Peer Review of the HB02 Pump Test (October, 2009) and the PB Report
“Broke Groundwater Investigation and Monitoring Report - AGL Hunter
Gas Project”.

DRAFT FOR DISCUSSION AT 24 MARCH 2010 BCCC MEETING

Professor Garry Willgoose
24 March 2010

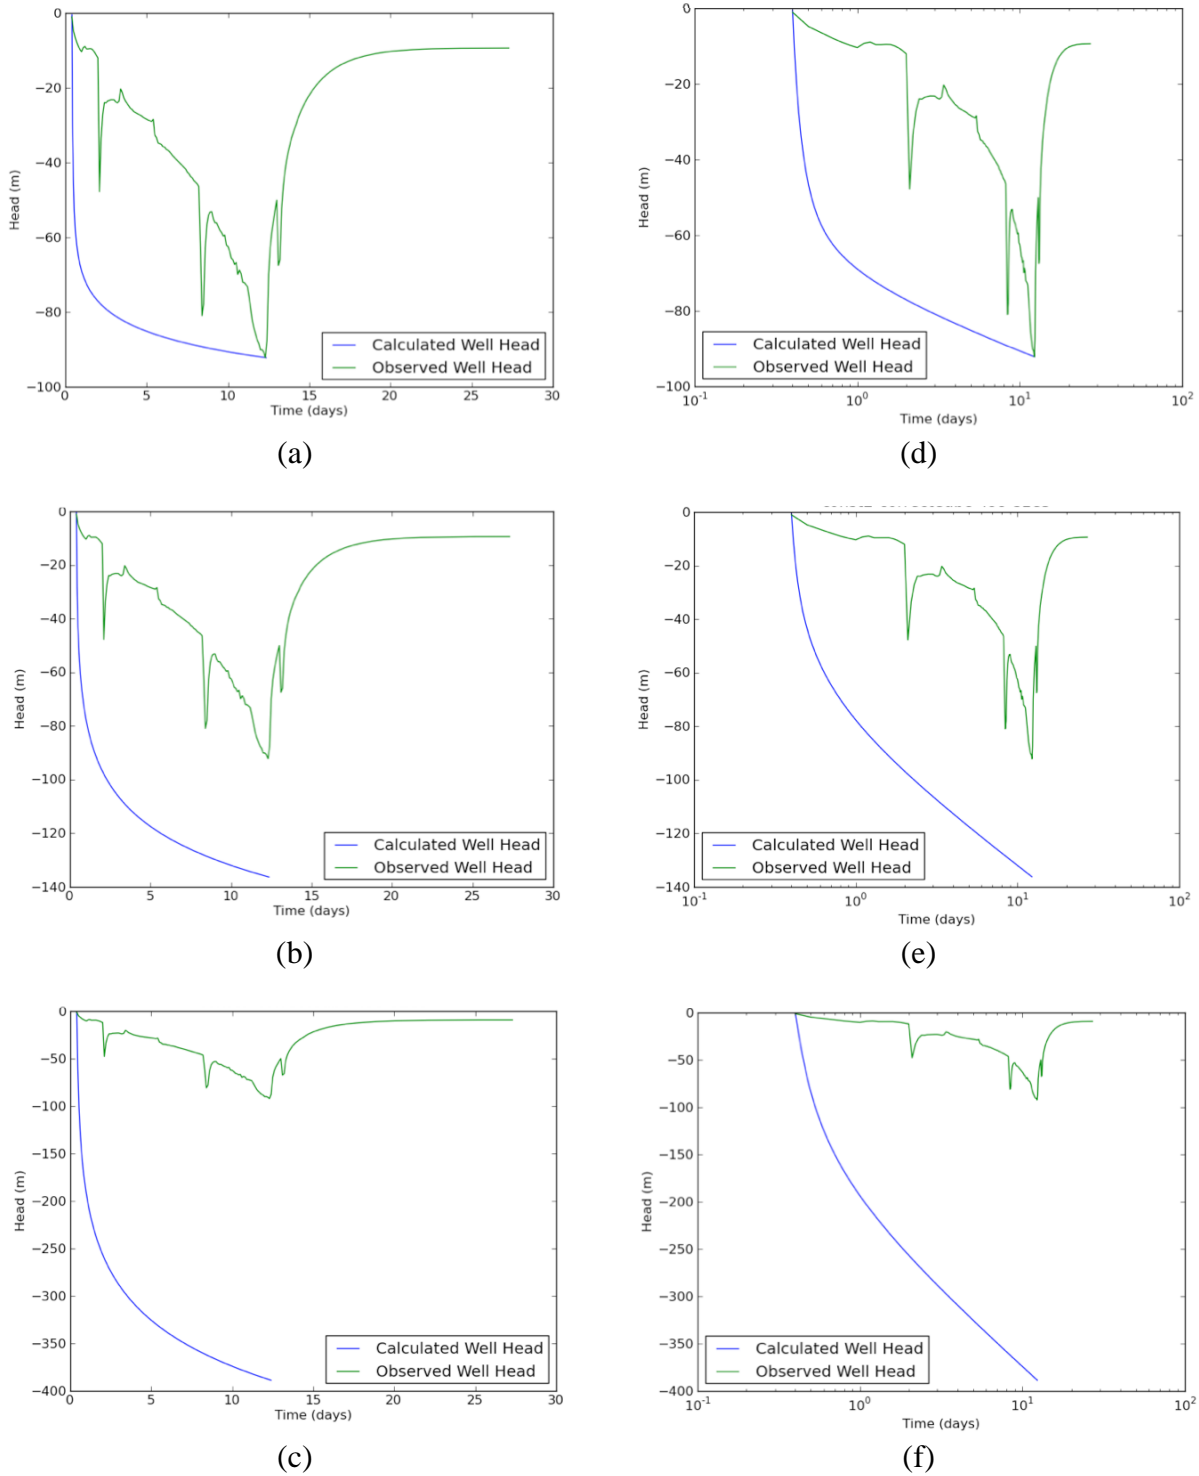
The first set of simulations used the 3 conductivities as derived by PB in their Table 6.5 and listed in Table A2. The pumping rate was the pumping rate for the period of the pump test for which the conductivities were derived. The time period listed in Table A2 is the simulation time used in the all of the figures below, which are relative to the start of the pump test. The results are shown in Figure A1.

The reader is cautioned that it is not expected that these results will fit the pump test data (also plotted in the Figures) because the simulations do not use the actual pumping rates (that change in time through the test). The figures are provided simply to show the rate at which convergence to asymptotic behaviour (i.e. linearity on the semi-log plot in Figure A1) occurs. It is clear that that in all cases it is several days, and in cases longer than the period over which the three conductivities are derived. This impacts on the conductivities derived by PB analysis, as it means that one of the assumptions of the Jacob method is invalidated. Finally, the asymptotic slopes of the 3 computer simulated drawdown curves are the same as the slopes of the regions of the pump test from which the conductivities were derived. This confirms that the computer code is yielding correct results given the conductivities used in the modelling.

However, one important conclusion is consistent with the PB interpretation of the time trend of the pump test. As the pump test proceeds the observed rate of well drawdown steepens (i.e., the drawdown curve gets steeper with time, particularly obvious in Figure A2d-f). Figures A1 and A2 show that this steepening is unlikely to be a result of the increasing pumping rate during the test because the model does not show a similar trend. Rather it is likely to be a result of a decreasing conductivity of the aquifer with distance from the well. This supports the conclusions in the PB report that, even though they misapplied the Jacob method (and thus their conductivity estimates are likely to be inaccurate so their conductivities are likely to be too low), their conclusion that the aquifer conductivity decreases with distance from the well is likely to be correct.

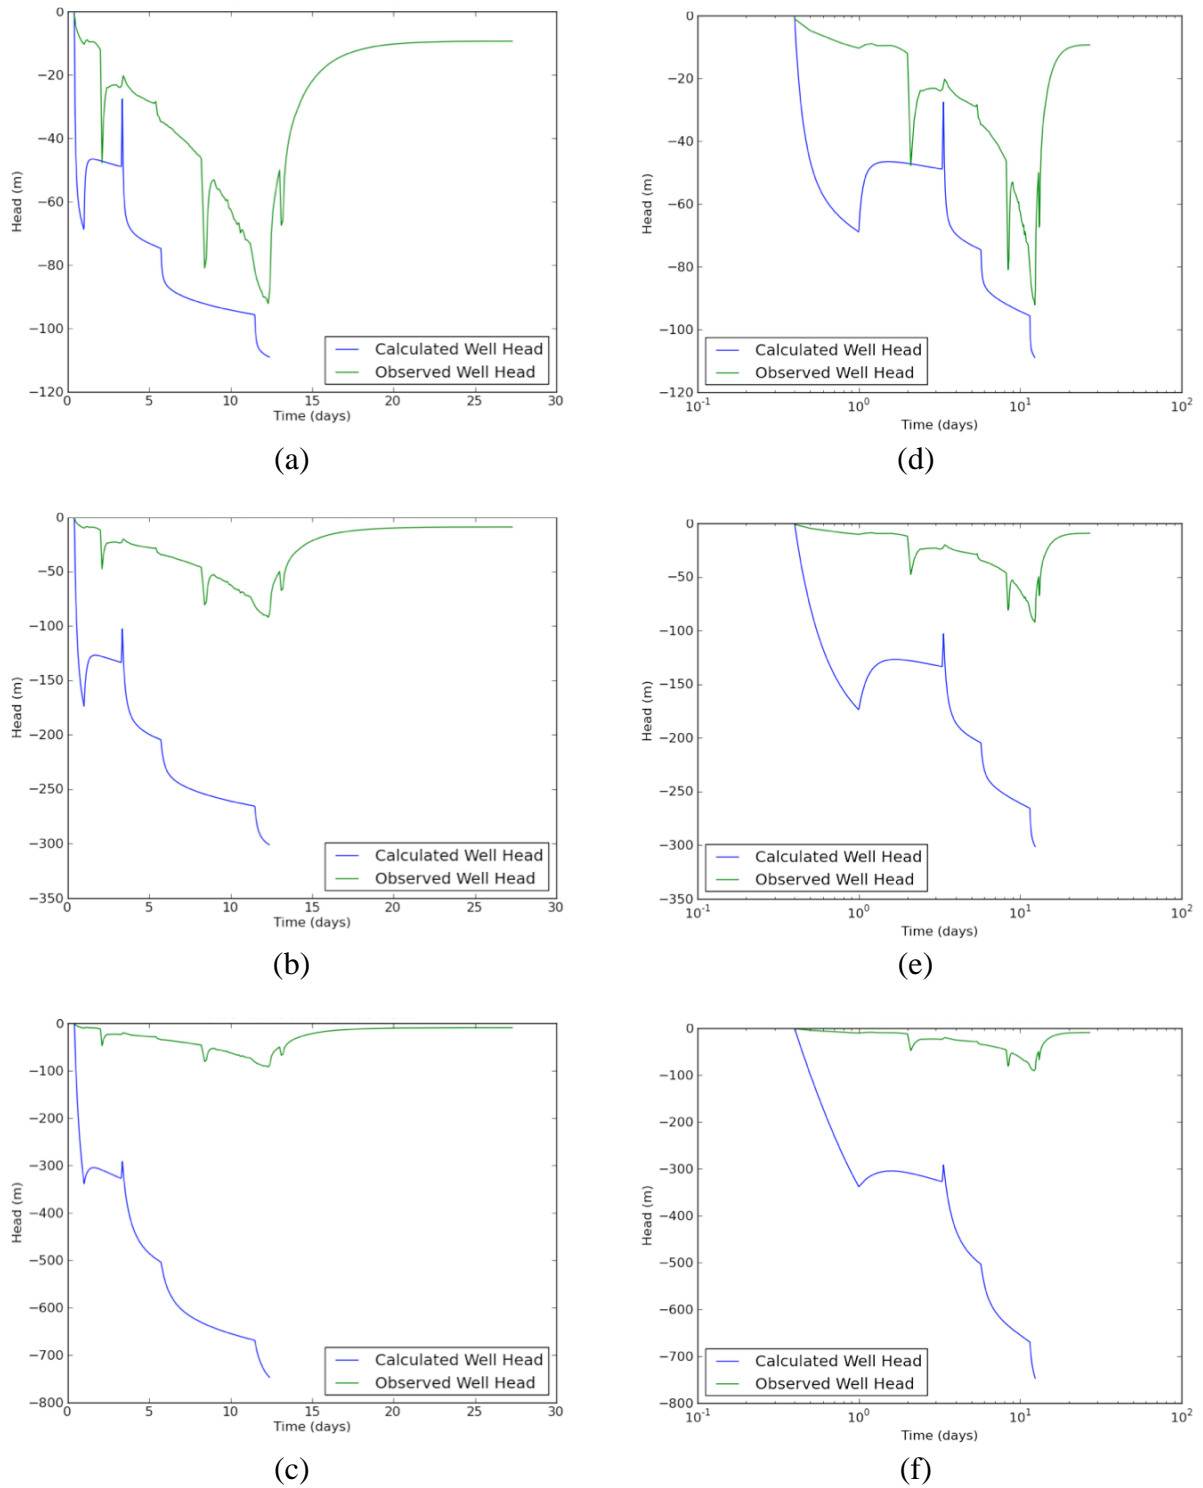
The second set of simulations repeated the first set of simulations but used the actual pumping rate as performed during the pump test. These results would be expected to provide a good fit to the observed well drawdown if the aquifer had the same conductivity everywhere in the aquifer as used in the computer model. These results are shown in Figures A3 and A4. None

of the conductivities provide a good fit to the data and in the following sections explore some alternative conductivity cases will be explored. The poor results in Figure A2 confirm that the aquifer conductivity is not constant in space.

Figure A3: The best fit parameters for the first 5 days of the pump test (a) the PB conductivity $K=0.043\text{m/day}$ (b) a sensitivity study with $K=0.08\text{m/day}$

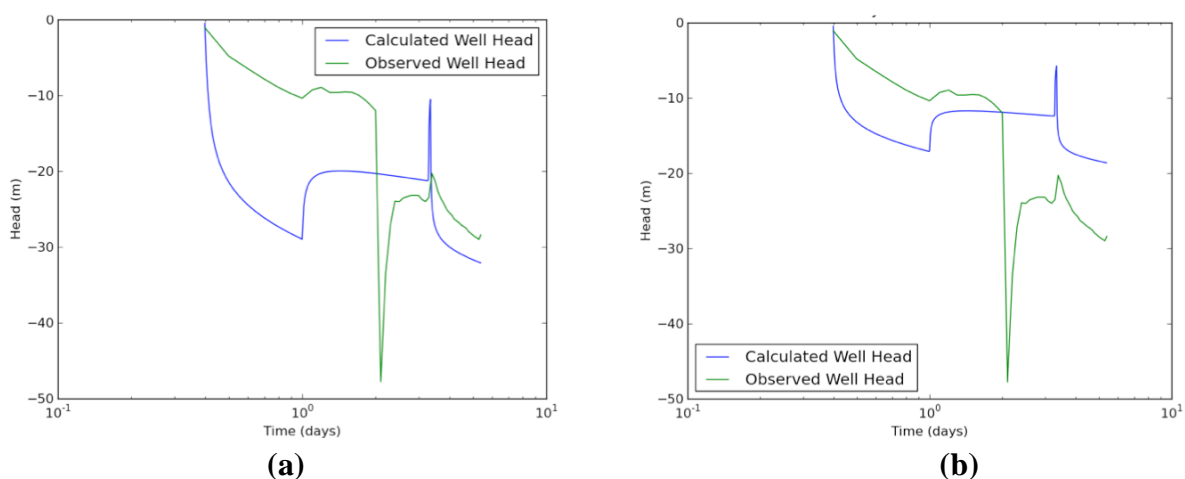
The parameters fit by PB to the first day of the drawdown do provide the best fit to the first 5 days of the data (Figure A3). The initial amount of drawdown is too large, but this is function of the storativity not the conductivity. The match in conductivity is indicated by the match between the slopes of the data and model results. Figure A3 also shows a result for a slightly higher conductivity of $K=0.08\text{m/day}$, which shows the sensitivity to a change in conductivity. The initial drawdown is less but the rate of subsequent drawdown is too low.

Figure A4: Best spatially variable conductivity (a) (b) $K=0.08\text{m/day}$ at well, (c) (d) $K=0.043\text{ m/day}$ at well.

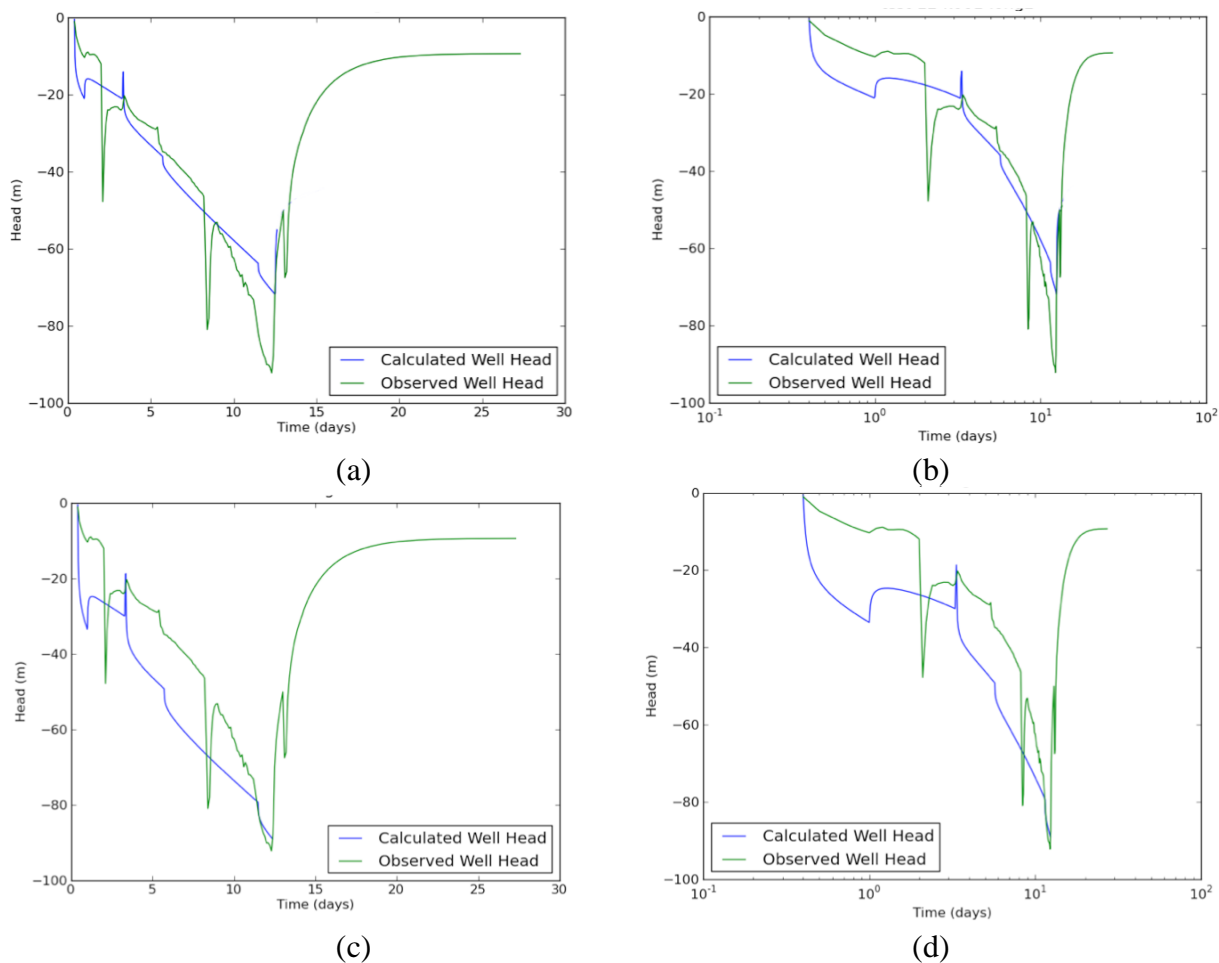
Accordingly a number of configurations for the spatial variation in conductivity were investigated. It was not possible to obtain a good fit to the overall drawdown if the initial conductivity of $K=0.043\text{m/day}$ was used but good fits were obtained with an initial conductivity of $K=0.08\text{m/day}$ (Figure A4).

The result in Figure A4 uses a linear drop in conductivity with distance from the well. The conductivity at the well is 0.08 m/day , dropping down to 0.005 m/day at 10m and dropping to 0.001m/day at 12m and then 0.0001 m/day at 18m and further out. This suggests that as the

Figure A7: Simulations of well drawdown in the presence of leaks at (a) No leak baseline case, (b) 5m from well, (c) 10m from well, (d) 20m from well.

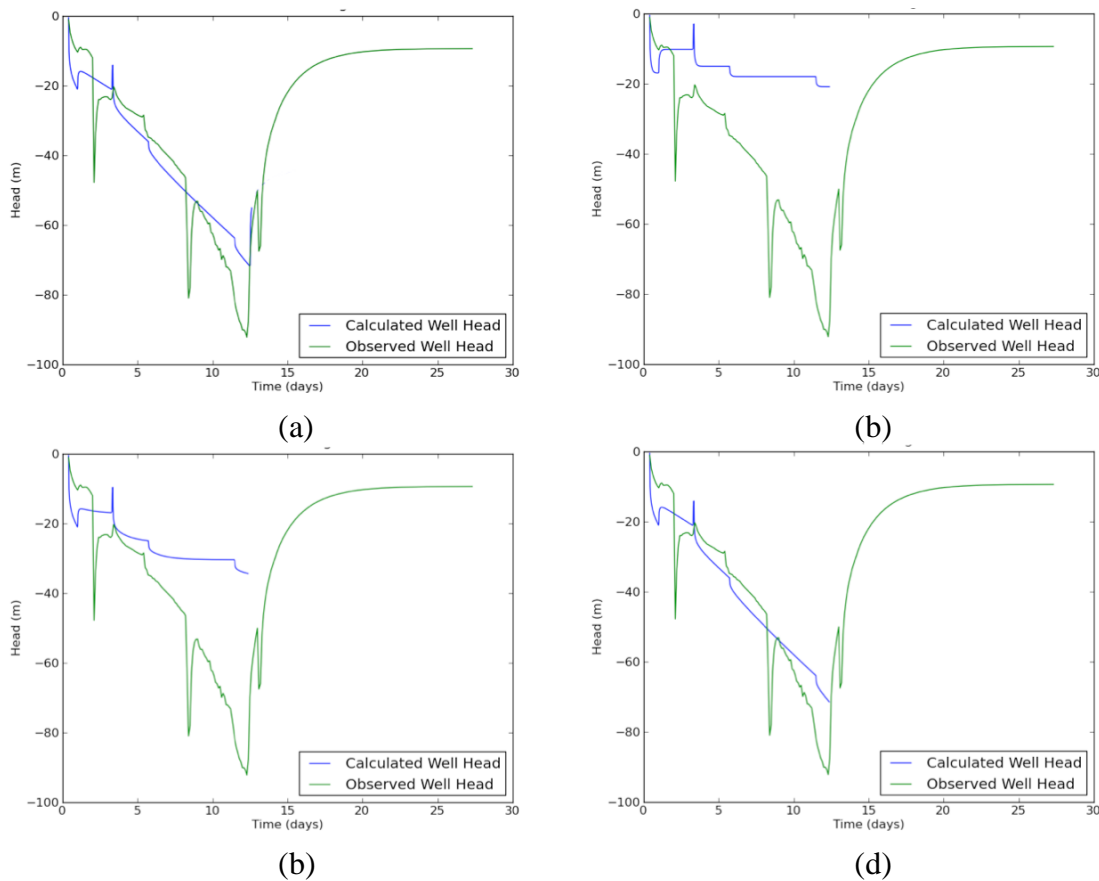
These figures show the classic symptoms of point aquifer leakage.

- (b) The second is that a point leak exhibits itself as a reduced drawdown in the well. This is because the leak means that it is easier to extract water from aquifer because you are not only drawing from the aquifer but from the leaky point. This is because the leak is replacing water that has just been pumped out.

- (c) The classic symptom of a point leak is that the drawdown curve is concave up (i.e. its get less steep with time) and it tends to a horizontal line with time (the steps in the horizontal line in Figure A7 reflect changes in the pumping rate during the test). After the time the drawdown has reached a constant value there is balance in the aquifer with the amount of water being pumped equal to water leaking into the aquifer. Note that this is not the same as saying that we are pumping out water from the leak because, at least initially, it will take some time for the water at the leak to travel to the well. The geochemistry of the water will be the geochemistry of the aquifer not the leak. So that at least initially the geochemistry of the water won't change. The lesson is that geochemistry is a lagging indicator of leakage.

The conclusion of this analysis is that the well drawdown from the pump test does not show any of the classical symptoms of a point leak located within the cone of depression created by the pump test. Accordingly I conclude that there are no point leaks within the cone of depression (within about 20-50m of the well) created by the pump test.
